# NewCold Cold Storage Modification 2

State Significant Development Modification Assessment  
(SSD-6799-Mod-2)

Published by the NSW Department of Planning, Industry and Environment

Figure 4 | Site plan of development, as approved through Modification 1

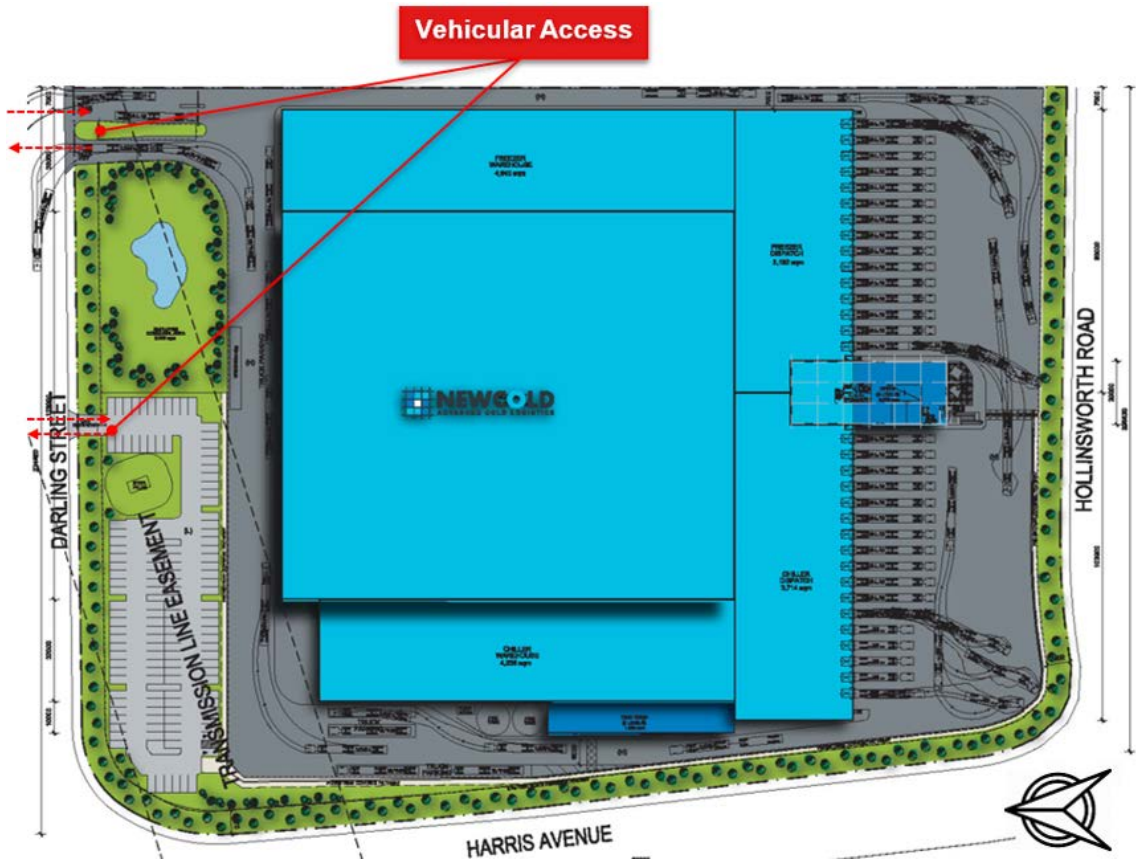
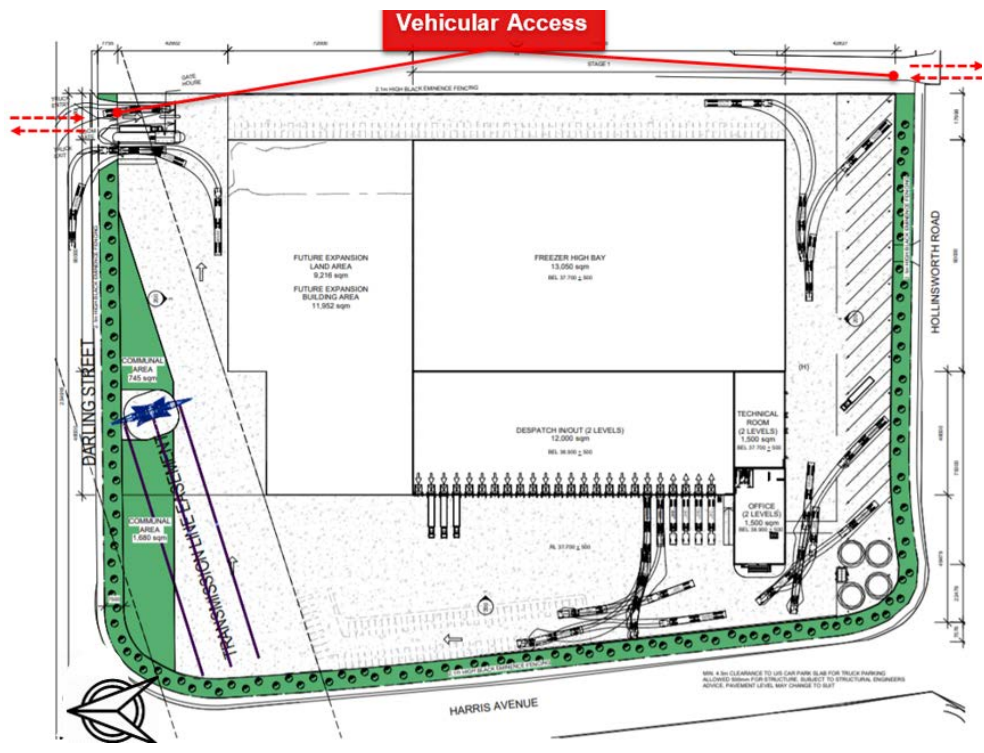
**Transport for NSW (TfNSW)** raised concerns relating to the proposed relocation of vehicular access from Darling Road to Hollinsworth Road specifically, that the location of the access on Hollinsworth Road could create negative impacts upon the intersection of Hollinsworth Road and Harris Avenue. TfNSW requested the Applicant demonstrate the following:

Issue	Findings	Recommendations
<b>Vehicular Access</b>	<ul style="list-style-type: none"> <li>• The development, as originally approved, included three access points off Darling Street (see <b>Figure 4</b>) comprising of:               <ul style="list-style-type: none"> <li>○ car park ingress/egress</li> <li>○ truck ingress</li> <li>○ truck egress.</li> </ul> </li> <li>• This modification seeks to amend the site access arrangements for the development (see <b>Figure 5</b>) to:               <ul style="list-style-type: none"> <li>○ consolidate the truck ingress and egress into a combined two-way driveway off Darling Road</li> <li>○ relocate the car park access onto Hollinsworth Road.</li> </ul> </li> <li>• The amendment is sought as a result of the relocation of car parking previously located along the Darling Street frontage, to a built platform along the Hollinsworth Road frontage.</li> <li>• TfNSW raised concerns with the relocation of the car park access from Darling Street to Hollinsworth Road, primarily due to the proximity to a future planned intersection between Hollinsworth Road and Harris Avenue. TfNSW commented that the location has the potential to compromise the safety of the local road network.</li> </ul>	Require the Applicant to: <ul style="list-style-type: none"> <li>• comply with the existing conditions of consent, including the requirement to prepare and implement an Operational Traffic Management Plan.</li> </ul>

- In response, the Applicant relocated the proposed driveway on Hollinsworth Road from 75 m east of the intersection, to 120 m east of the intersection.

- TfNSW reviewed the RTS and raised no objection to the changes sought to access arrangements.
- The Department has reviewed the changes sought to access arrangements, and the relocation of the car parking and concurs with the advice provided by TfNSW that safe access can be achieved to the site. Furthermore, the separation of truck and car access points creates a clear delineation for staff and visitors entering and exiting the site.
